As discussed, works at Banff Bridge are progressing, with Phase 1 underway. The sheet piles have been installed and the area de-watered, including the fish rescue, and the riverbed has been taken down to formation level in preparation for the mattress installation.

On this basis, I would like to request a Variation to Marine Licence MS-00010983 and would be grateful if you could give this your consideration.

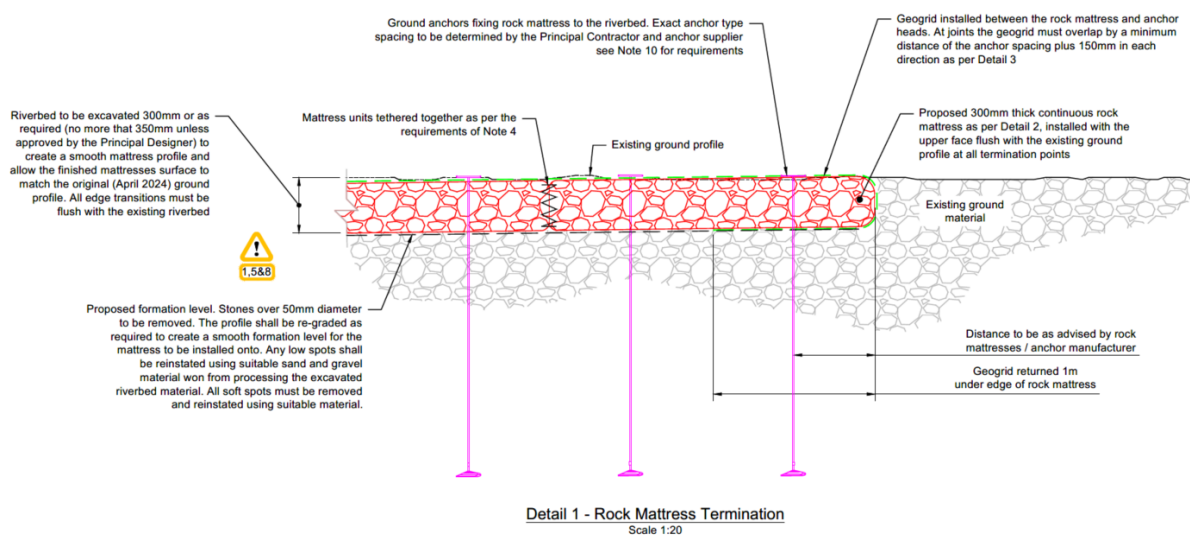
The intended detail for the toe of the rock mattresses (see image1 below) where the rock mattresses were to tie-in to existing bed material has required to be revised and re-designed. A sketch of the proposed revised detail is attached.

What this now means, is that rather than 553m<sup>3</sup> of site won riprap stone being utilised in the scheme, with 503m<sup>3</sup> of rip rap stone being removed from the riverbed, as described in paragraph 2.4 of the Marine Licence, we will now require to use the additional material to form the toe detail. Essentially, all 1056m<sup>3</sup> of material will now be used in the works. The footprint of the work will remain unchanged.
